**MUNICIPAL SERVICES CENTER, COUNCIL CHAMBER
3600 TREMONT ROAD**

Subject: 2286 Yorkshire Road (VAR-52-23) - To allow an addition to encroach up to 3'-11" into the 10-foot minimum south side yard setback, up to 6'-3" into the 12'-4" side yard longwall setback, and results in a side yard sum of 12'-5" (13'-5" existing), when 20 feet is the minimum.

ZAFIRIDES RESIDENCE - UPDATED DESIGN + UA BZAP VARIANCES - 12.29.23

SHEET NAME
EXISTING + NEW
FLOOR 2 PLANS

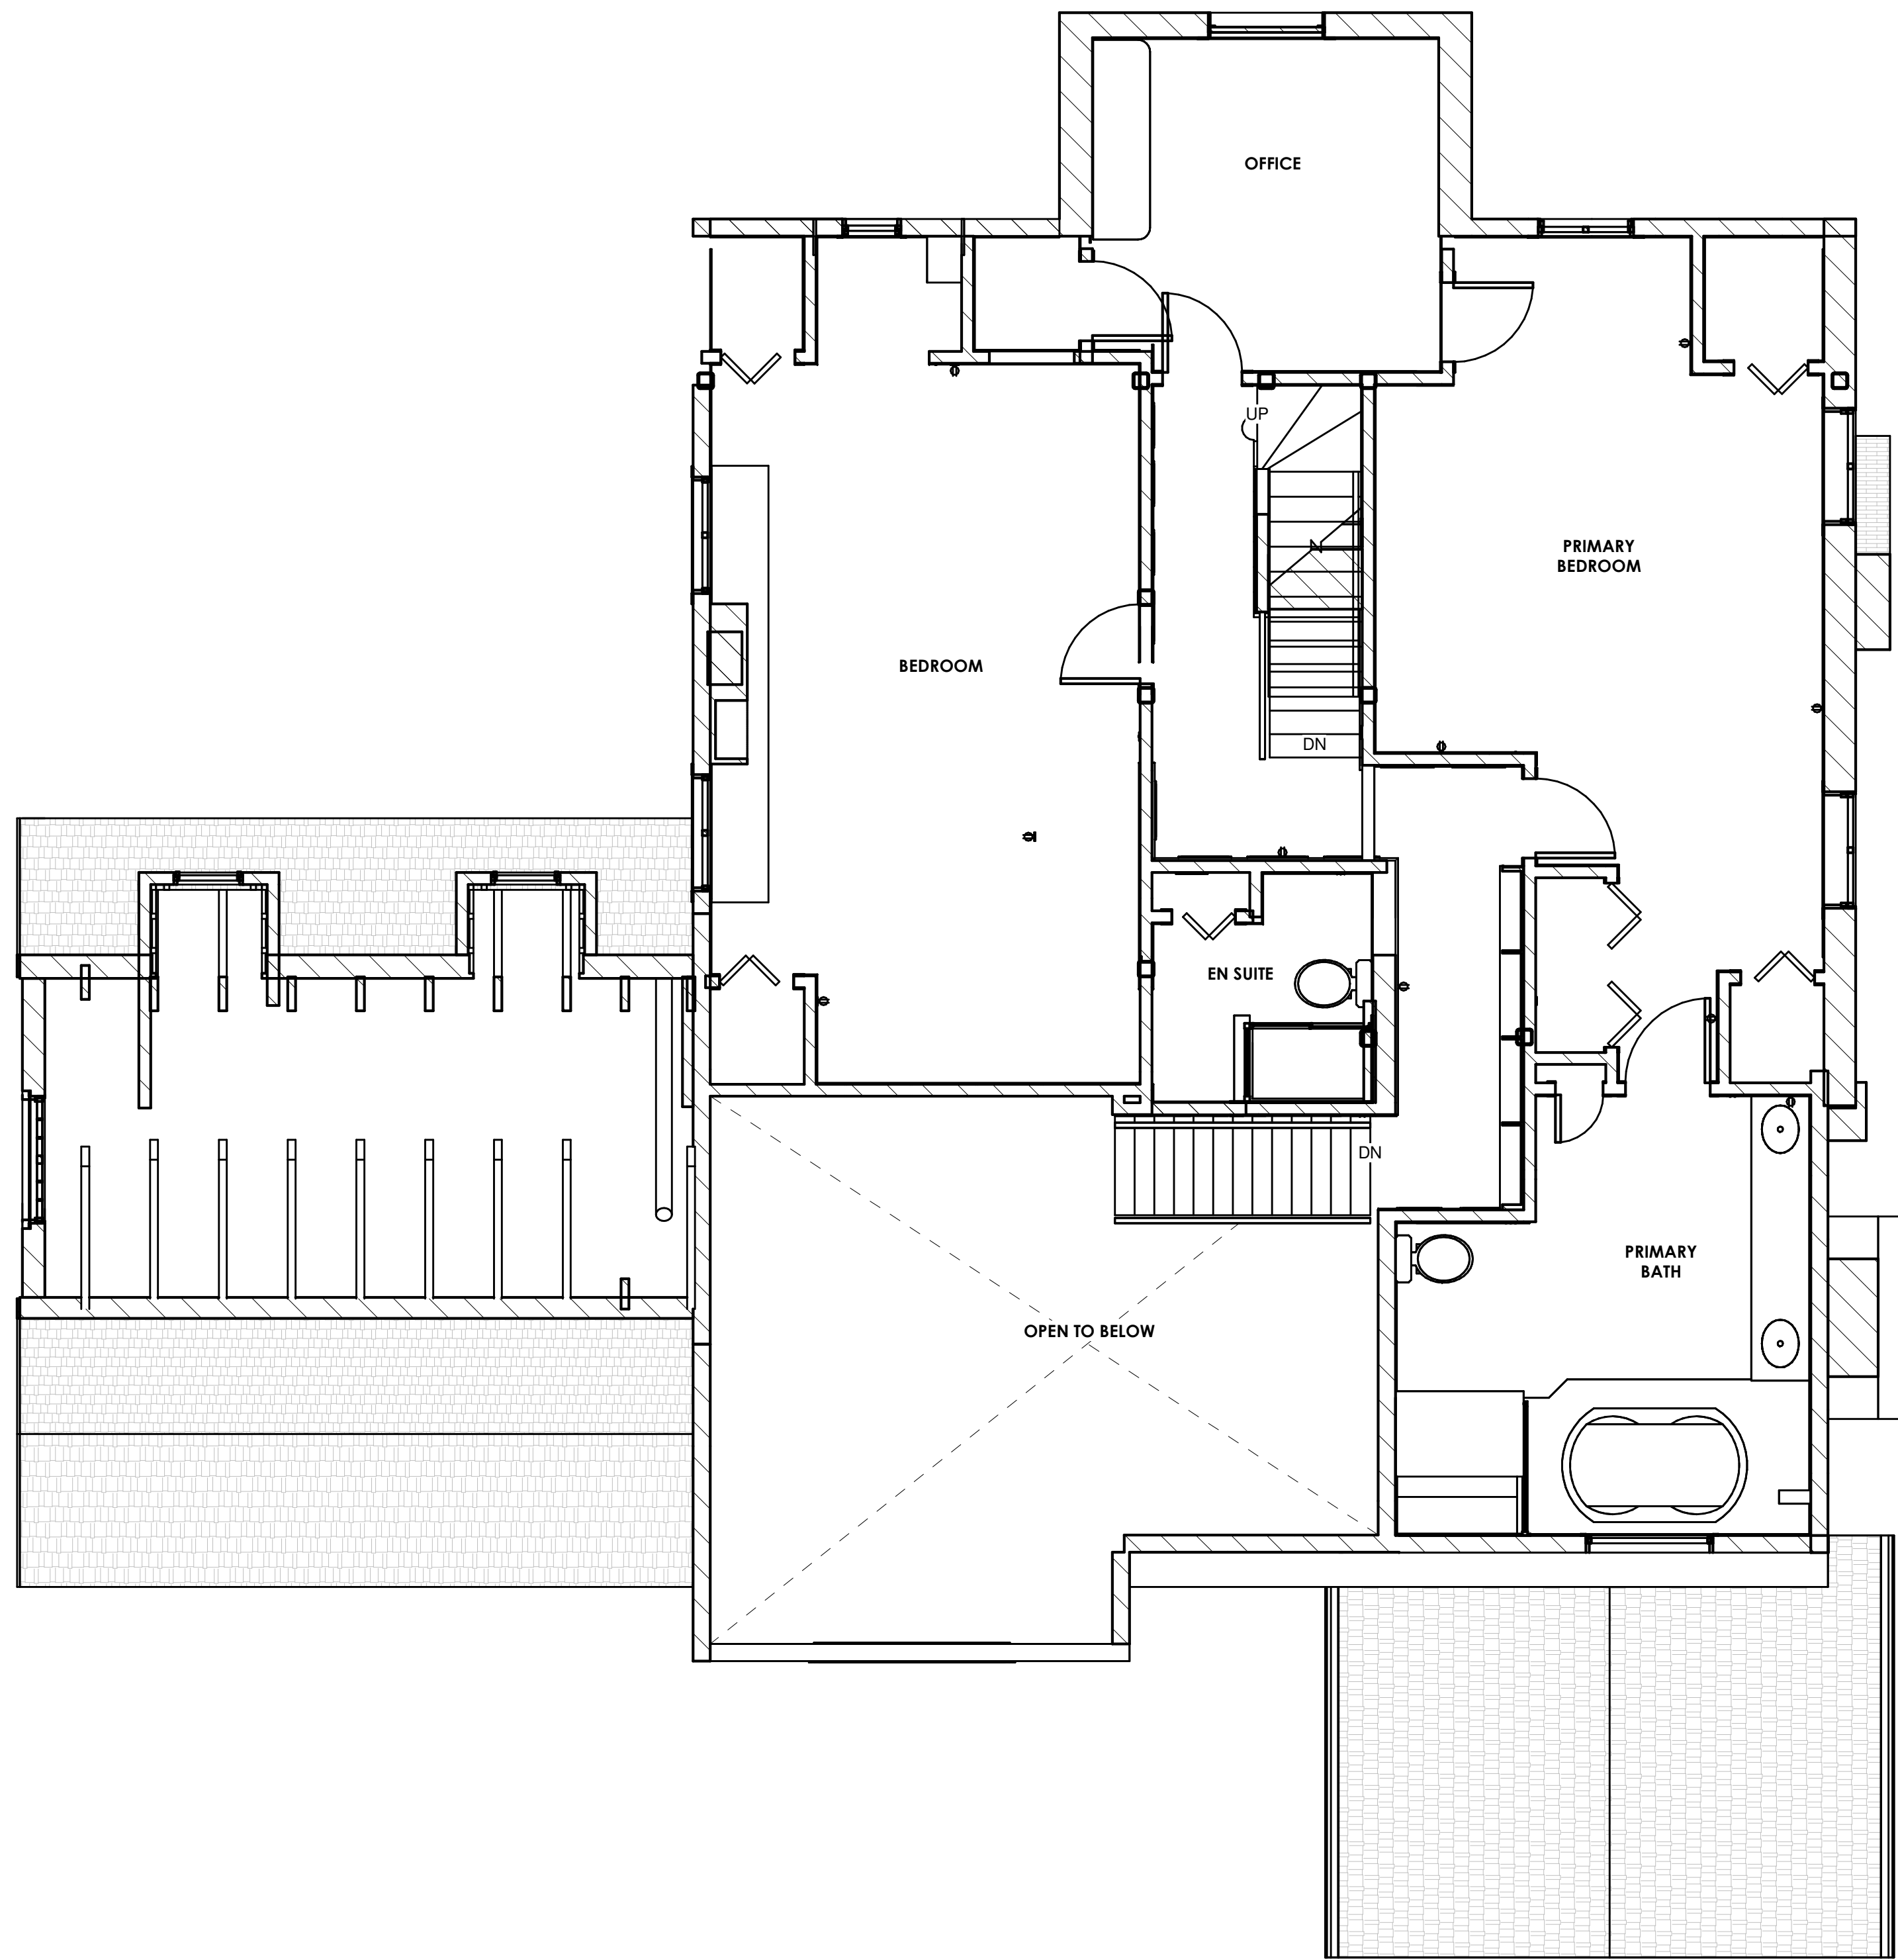
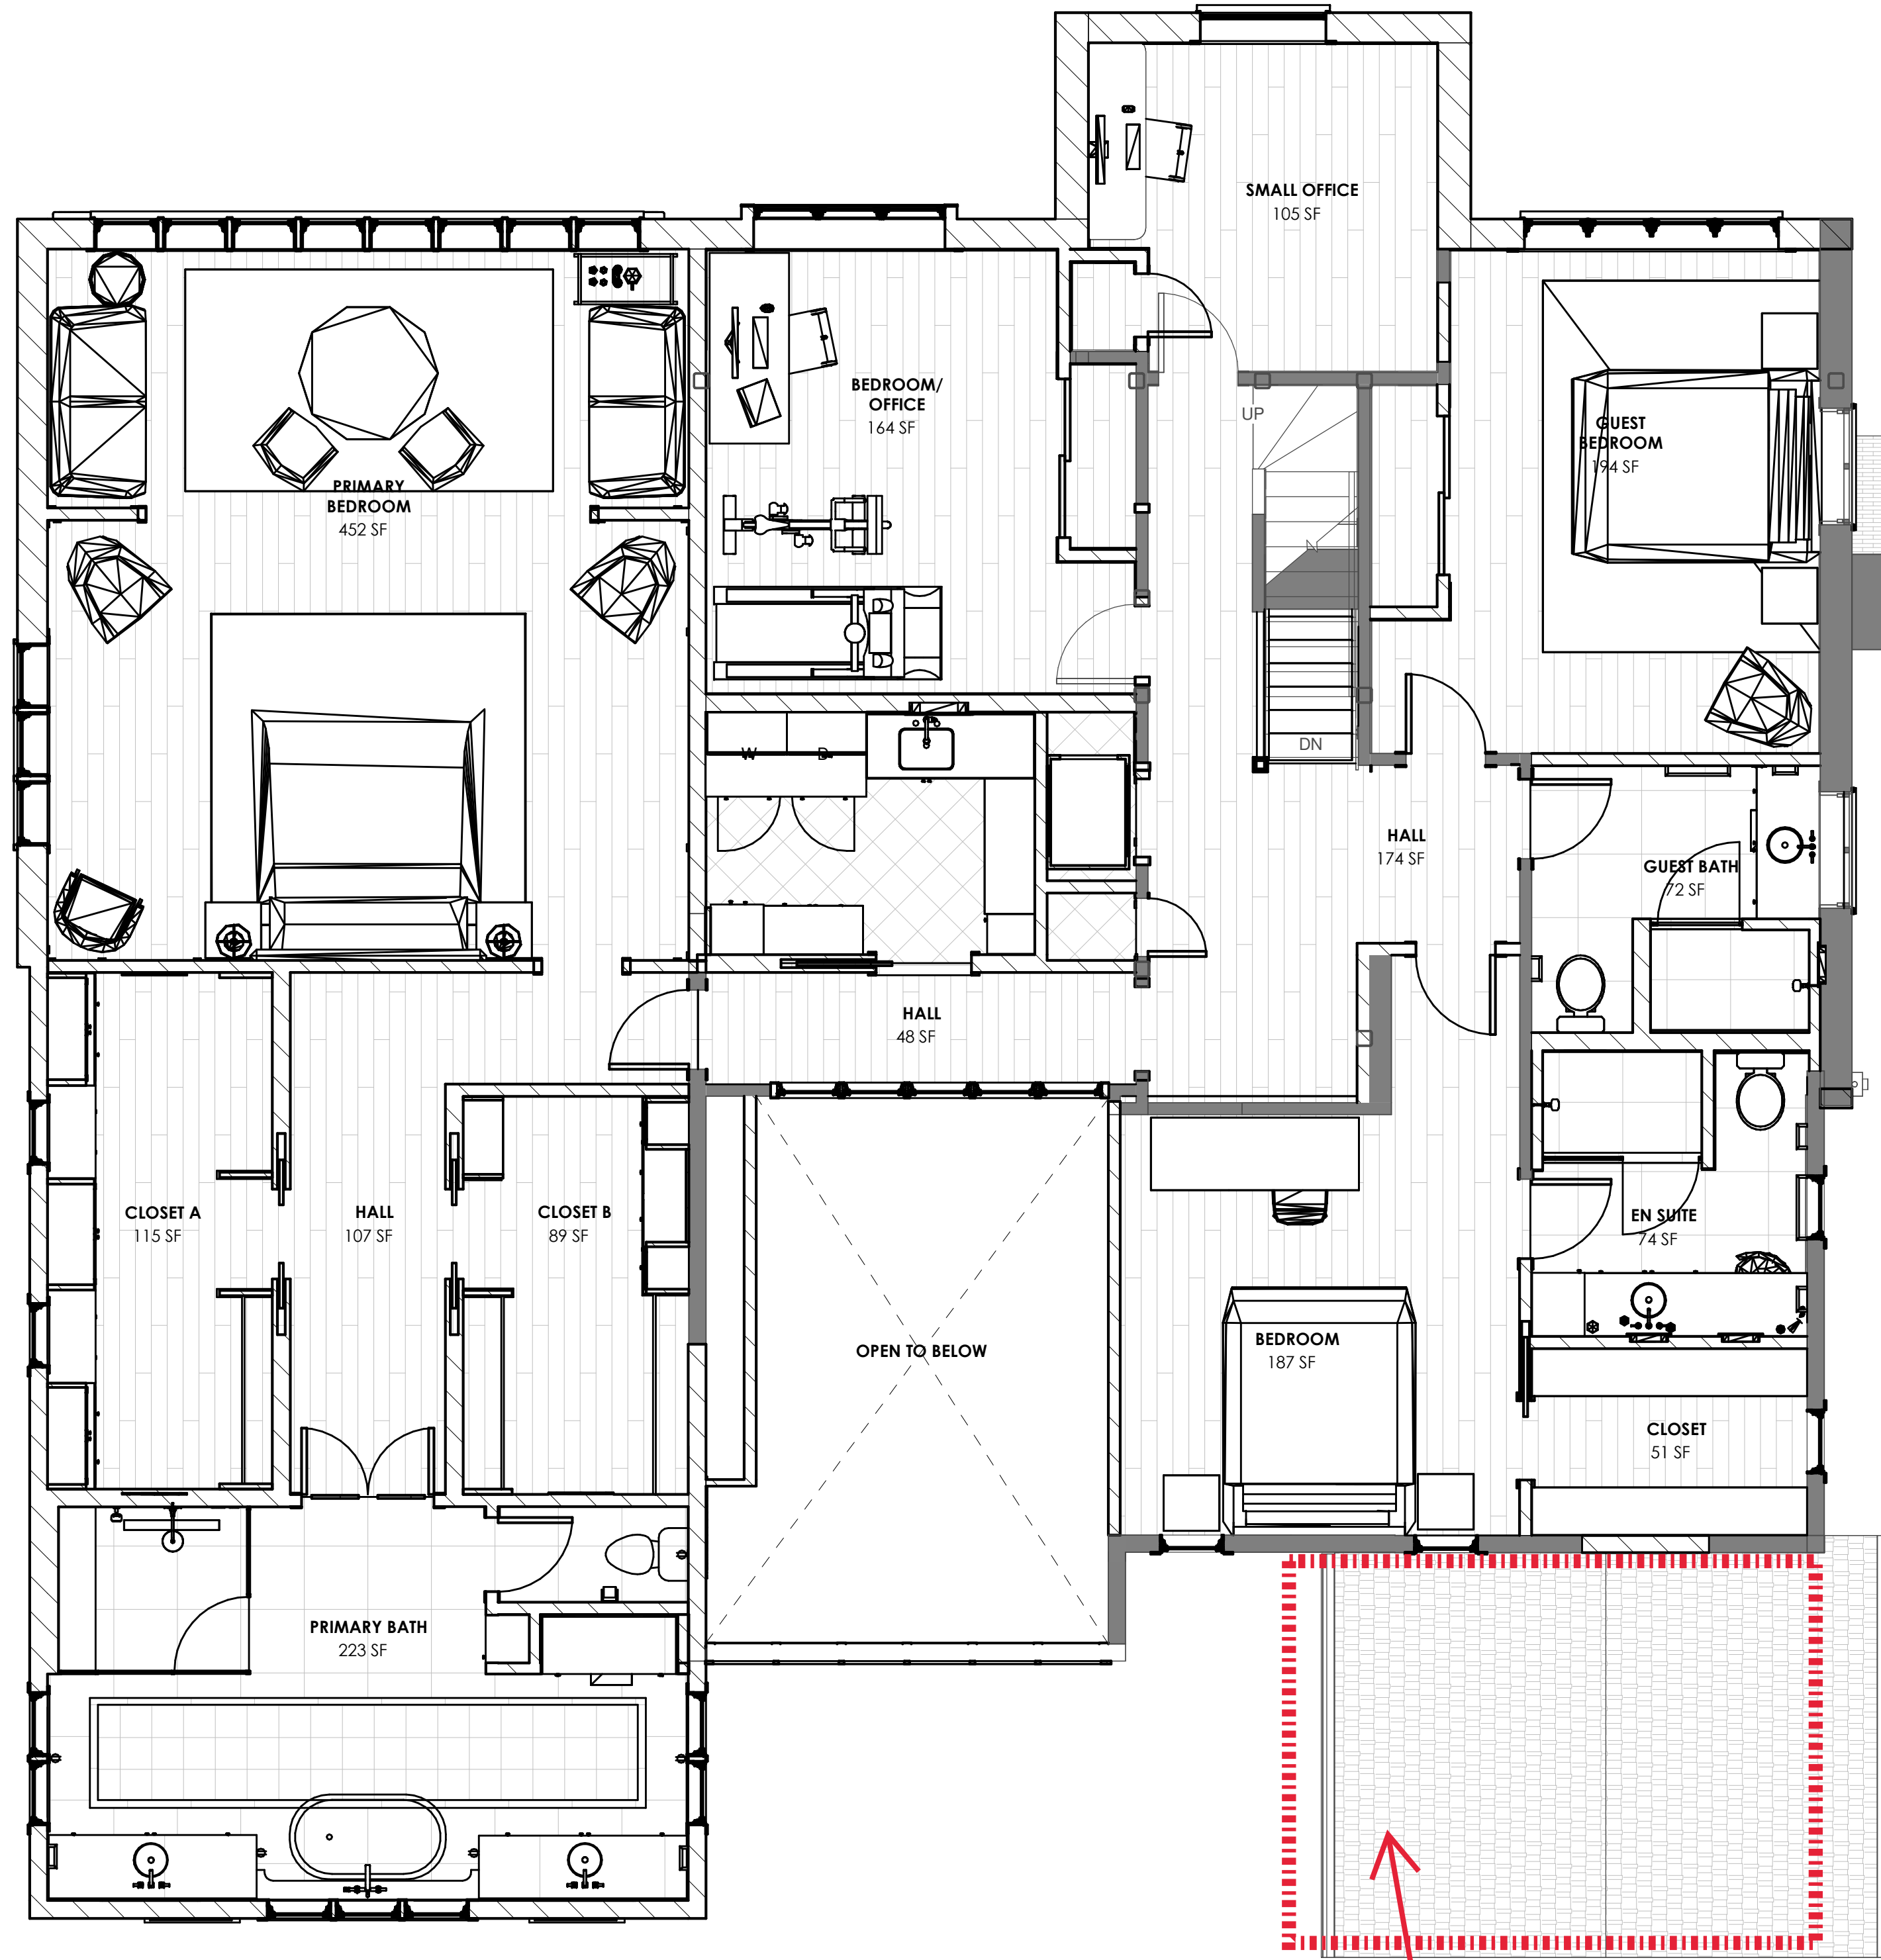
no second floor
addition at north wing
of house
